Title: Permit #25-041: Whittier Park Playground Reconstruction

Prepared by: Name: Veronica Sannes, Permitting Technician
Phone: (952) 641-4580
Email: vsannes@minnehahacreek.org

Recommendation:

Approval of MCWD permit 25-041 in accordance with the submitted plans and following conditions:

GRADING, DRAINAGE & EROSION CONTROL PLAN

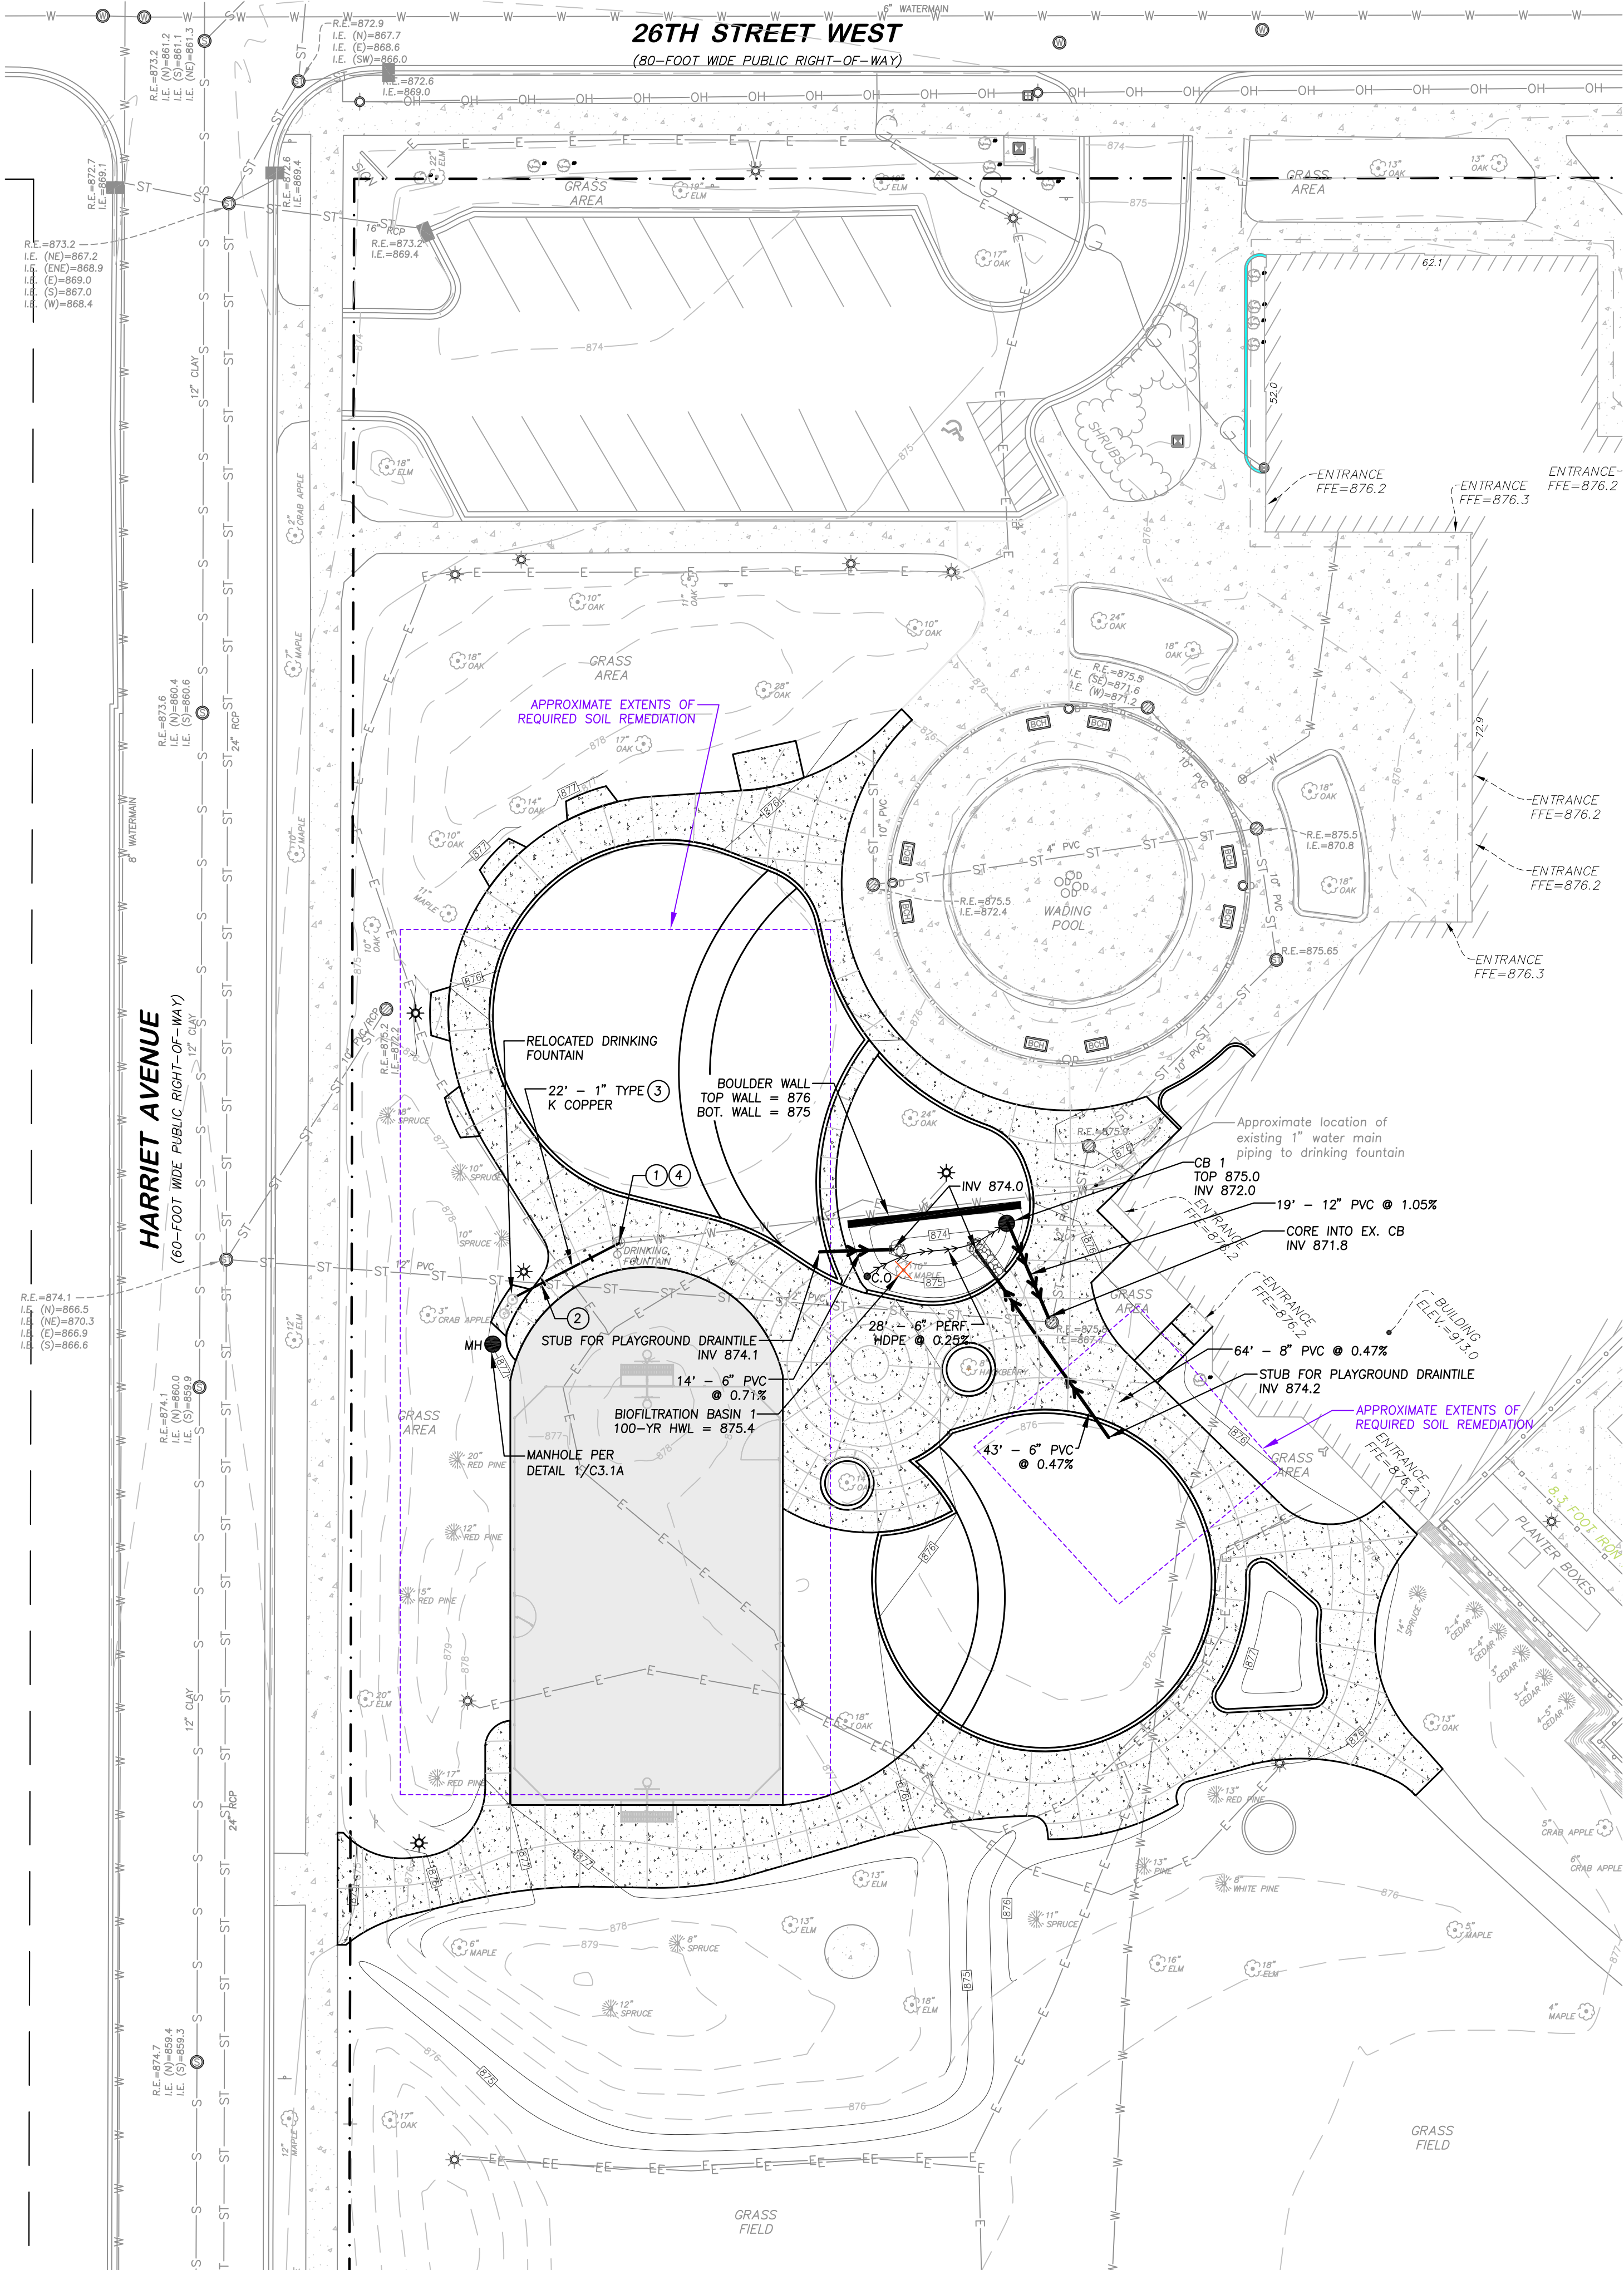
Section 6 requires that two feet of vertical separation or hydraulic disconnection be provided between the 100-year high water level and the nearby low opening of the recreation center. The proposed BMP does not meet this requirement, and the Applicant is requesting a variance from this section of the rule, as explained in greater detail under the "Variance Request" section.

The cause of difficulty resulting in the variance request is a combination of the site's existing drainage patterns and topography, the elevation of the existing recreation center's low opening, and regulatory requirements from MCWD and the City of Minneapolis. The entire site is very flat with elevations at approximately 875 ft and the existing building's low opening is at the elevation of 876.2 feet, meaning it is difficult to achieve 2 feet of vertical separation anywhere on the

site, while the emergency overflow (EOF) route of the entire site is 875.55 ft, meaning that if grading is below 875.55 ft, the overland flow path will not drain off the site. The Applicant is also constrained in the type of BMP to use for treatment because it is required to provide a BMP to meet MCWD regulations, and water quality treatment and rate control to meet City of Minneapolis requirements. None of the causes of the difficulty were created by the Applicant.

1. Basin Size: If the basin were sized to be deeper or larger, the 100-year flood elevation could meet the 2-foot freeboard requirement. However, the Applicant is unable to dig the basin deeper to gain the two feet of separation without compromising the required 3:1 side slopes of the basin. The Applicant is also not able to expand the footprint to gain the 2-feet of separation without having nearby utility conflicts, losing playground area, and/or losing mature trees.

4. Alternative Location: A third alternative explored was moving the basin south of the playground area to achieve hydraulic disconnection. However, in order to continue capturing runoff from the required 0.37 acres of impervious surface to meet City requirements, the entire site would need to be regraded to drain south. This extent of regrading would result in significant tree loss in the park, trigger the need to export large quantities of contaminated soils, and increase project cost.
